# BWR OWNERS' GROUP

BWROG-02034  
March 14, 2002

Subject: BWR Owners' Group Comments to Draft Regulatory Guide (DG-1111),  
"Atmospheric Relative Concentrations for Control Room Radiological  
Habitability Assessments at Nuclear Power Plants"

BWROG CRH COMMITTEE  
UTILITY COMMENTS TO  
DRAFT REGULATORY GUIDE 1111 (Atmospheric Relative Concentrations for CRH)

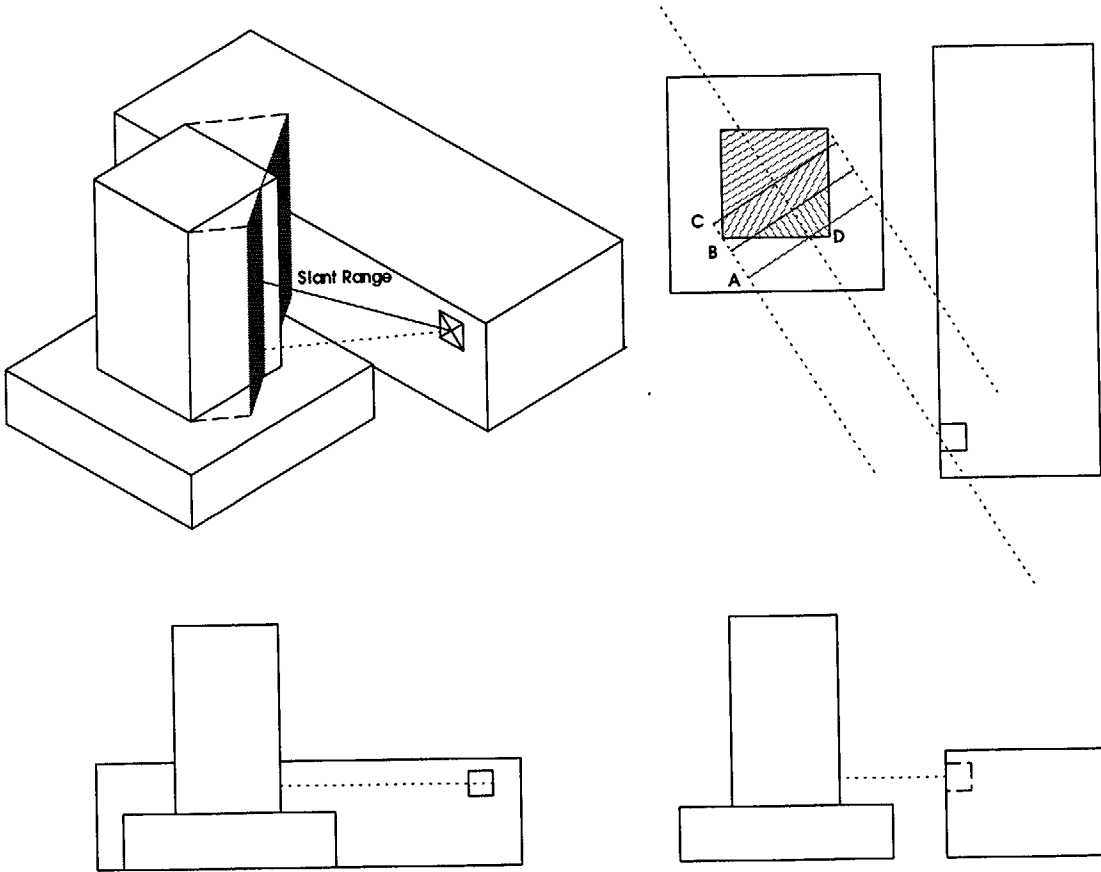
<b>DG-1111 REFERENCE</b>	<b>COMMENT</b>	<b>RECOMMENDED CHANGE</b>
Section C (Regulatory Position), Subsection 2.2.4.5	(See attached sketch) Use of the diffuse source option is permitted for releases from volumes with a homogeneous concentration of radiological source (2.2.4.1). The total release rate must be assumed (2.2.4.2). The RG restricts the selection of diffusion coefficients more than the values recommended in the NUREG (2.2.4.3). The shortest horizontal distance from the source-building surface along the line of sight to the source building centerline (Line A on the sketch) is used rather than a slant range to the geometric center of the effective diffuse source plane (2.2.4.5). Credit has not usually been allowed for holdup or retention in the release building (2.2.4.8), and decay during transport time is not credited by codes like RADTRAD. Based on these provisions, the guideline for calculating the source to receptor distance is probably more conservative than necessary.	<ol style="list-style-type: none"> <li>1. Base the source to receptor distance on the source building centerline (Line C on the sketch) or some point between the building surface and the centerline. (e.g., Line B on the sketch is approximately half the distance between the closest point along the line from the intake to the source building center and the source building centerline)</li> <li>2. Allow the source to receptor distance to be a slant range.</li> </ol>
